RealSense™ Product Family

D500 Series

Specification Update

Revision 004

7.1 External HW Sync

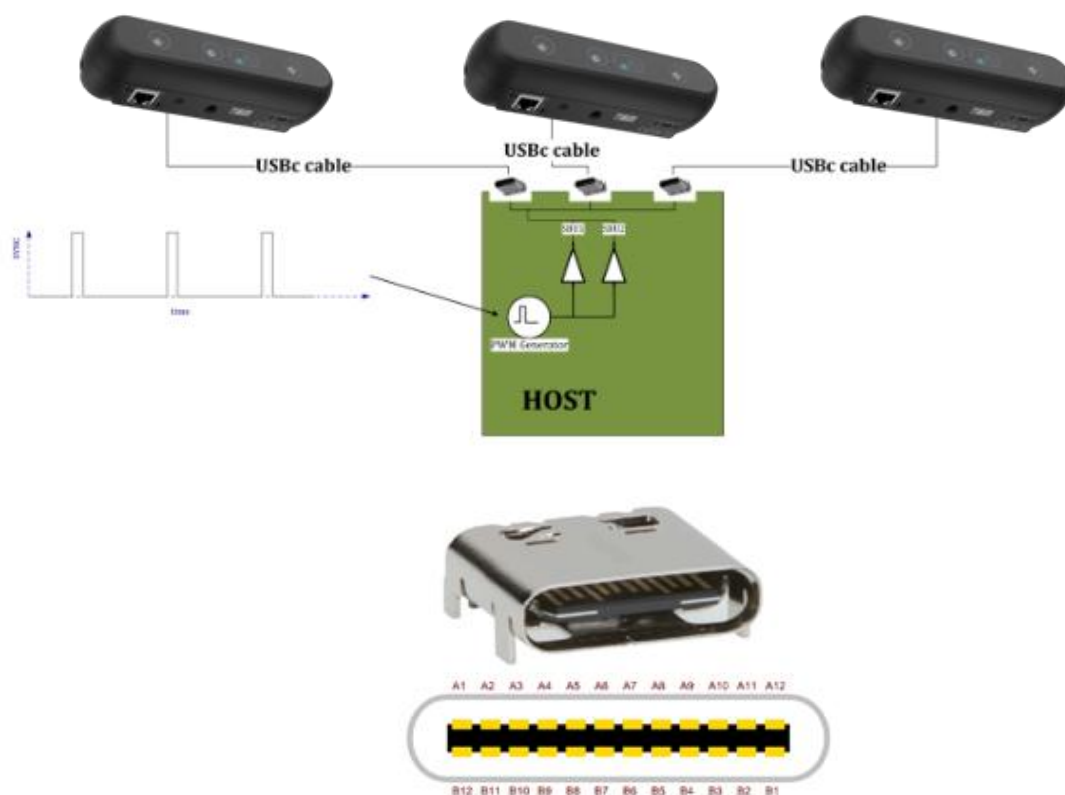
- Multiple cameras can be connected to one host and will be able to stream asynchronously independent data
- The cameras can be hardware synchronized (HW sync) so they capture at exactly the same time and rate
- The host will be the synchronization master, and the cameras will be working in slave mode
- An SDK API will be used to configure the cameras in slave mode
- The main difference between the D400 (Vision Processor V1 and V3) HW sync and D555:
 - D400 cameras HW sync use the 9pin aux connector—pins 5 (SYNC) and pins 9 (Ground)
 - D555 will use the USB type C connector 2 SB (sideband) pins, requiring connecting a USB type C connector on the host side as well
- Note: The RGB color sensor is synchronized with the depth sensors (left and right) when they stream at the same FPS
